VILLAGE OF ARLINGTON HEIGHTS
STAFF DEVELOPMENT
COMMITTEE REPORT

Project Number: PC 23-012
Project Title: Arlington Gateway Dev. – Phase I
Address: 1, 15, 111 E. Algonquin Road, 2355 S. Arlington Heights Road
PIN's: 08-16-401-018, -030, -036, -039, -043, -045, and -046

To: Plan Commission
Prepared By: Sam Hubbard, Development Planner
Meeting Date: November 29, 2023
Date Prepared: November 20, 2023

Exhibit II – Building Setback Variations

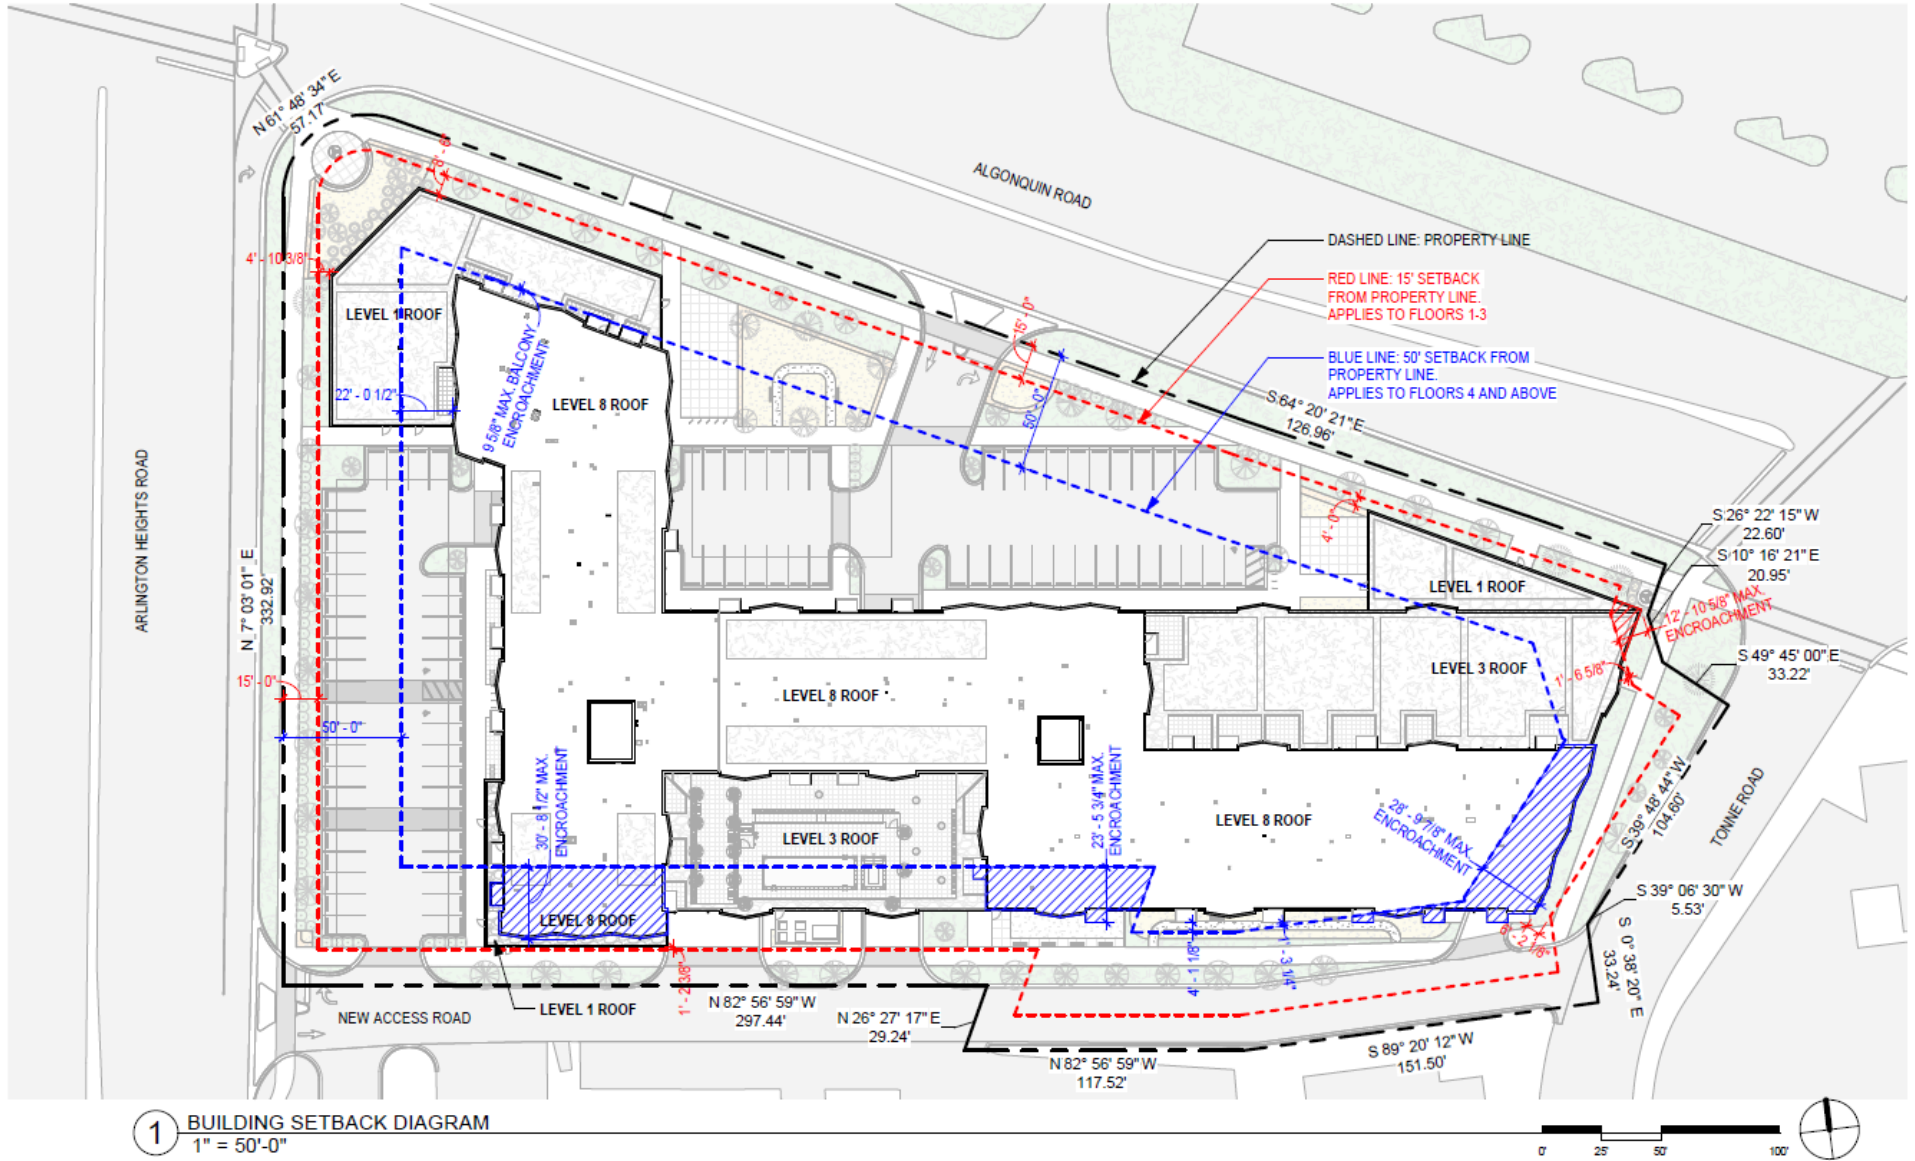
- 1. Section 5.1-21.1d, to allow the northeast corner of the 1st floor to be setback 2' from a property line where code requires a minimum 15-foot setback for structures 3 floors and less in height.**
- 2. Section 5.1-21.1d, to allow the eastern side of floors 4 through 8 to be setback 21.1' from a property line, and to allow the southern side of floors 4 through 8 to be setback 19.2' from a property line, where code requires a minimum setback of 50' for structures over 3 floors in height.**

Exhibit II, at the end of this report, depicts the location of these variations. The Staff Development Committee is supportive of variation #1 as the setback encroachment is a product of the irregular lot configuration at the northeast corner, which cuts into the property but is used as open space/parkway. The Staff Development Committee is supportive of variation #2 and notes that the 50' required setback for floors 4 and above was established in consideration of the maximum allowed building heights (20 floors) within the Overlay District. As the proposed building would be only 8 floors tall, is part of a master planned redevelopment area, and maintains all code required setbacks along the primary viewing corridors (Arlington Heights Road and Algonquin Road), the proposed setback variations are acceptable.
